TO: EMMA HETH, PLANNER II
FROM: CHRISTOPHER MCGINNIS, PUBLIC WORKS DIRECTOR/TOWN ENGINEER
RE: MAJ-24-004 (20 E MAIN STREET) ENGINEERING/PUBLIC WORKS REVIEW
DATE: MAY 23, 2025

The MAJ-24-004 submittals dated 05/15/2025 (civil plans) were reviewed for general conformance with Town Code, standards, and general engineering principles. Submittals reviewed include the civil plans and traffic study. Comments were added to the plans and are attached below; these comments shall be addressed by the applicant prior to issuance of building permit.

Revocable License Agreement

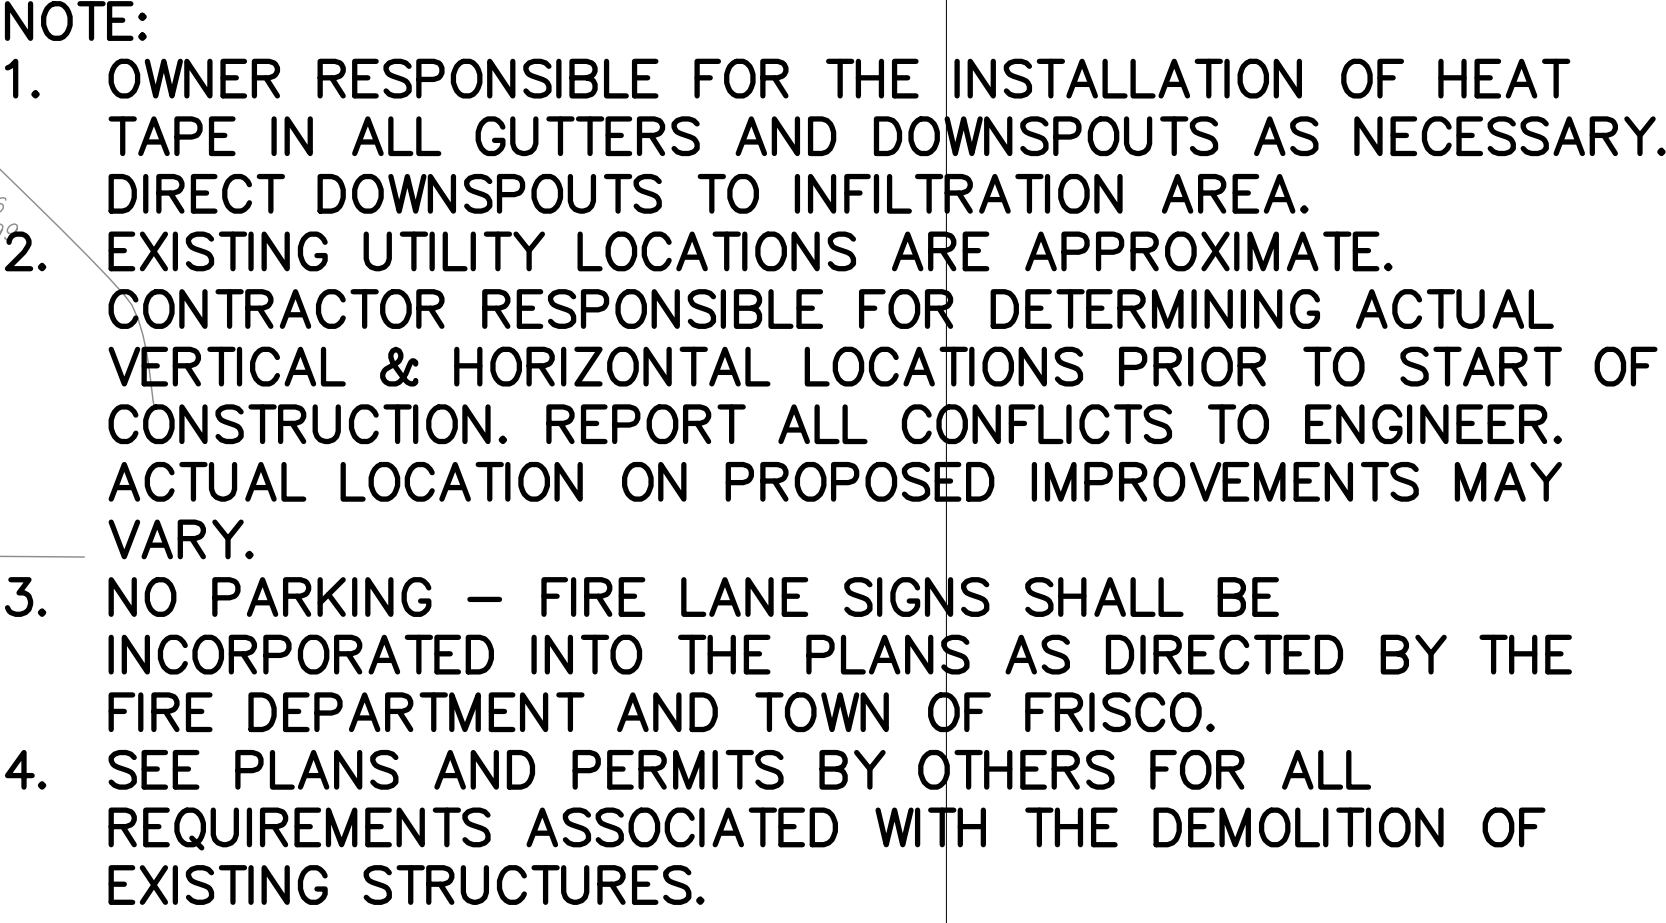
Landscaping, benches, and bike racks are being proposed in the ROW. These improvements would provide public benefit and be allowed in the ROW with the approval of a revocable license agreement. The civil plans show a wall within the ROW – this will need to be removed or approved through an RLA.
